**Re: Defect Information Report – Supplemental Report No. 3  
07V-532, FL-515, Windshield Wiper Motor Ground Wires**

## **Subject: Windshield Wiper Motor Ground Wires**

**Models Affected: Specific Freightliner Century Class S/T, Columbia, and Coronado vehicles manufactured between January 3, 2007, and October 24, 2007, with a certain windshield wiper motor harness.**

May 2008  
FL515A  
NHTSA #07V-532

Fig. 1, Left Side of Frontwall

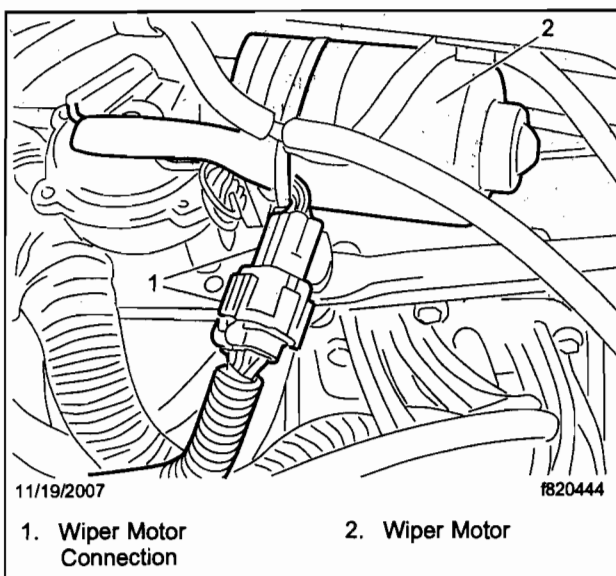
A windshield wiper motor ground wire was omitted from a new wiring harness design. Without this ground wire, the windshield wiper motor may function intermittently or not at all. In certain conditions, this could impair visibility, resulting in a possible vehicle crash if the vehicle is not stopped safely.

A ground wire will be added to the windshield wiper motor harness.

1. Check the base label (Form WAR259) for a completion sticker for FL515 (Form WAR260) indicating this work has been done. The base label is usually located on the passenger-side door about 12 inches (30 cm) below the door latch. If a sticker for FL515 is present, nothing further needs to be done. If no sticker is present, go to the next step.
2. Shut down the engine, set the parking brake, and chock the tires.
3. Raise the hood.
4. On the left side of the frontwall, find the wiring connection for the wiper motor. See Fig. 1.
5. Disconnect the halves of the wiring connector. See Fig. 2.
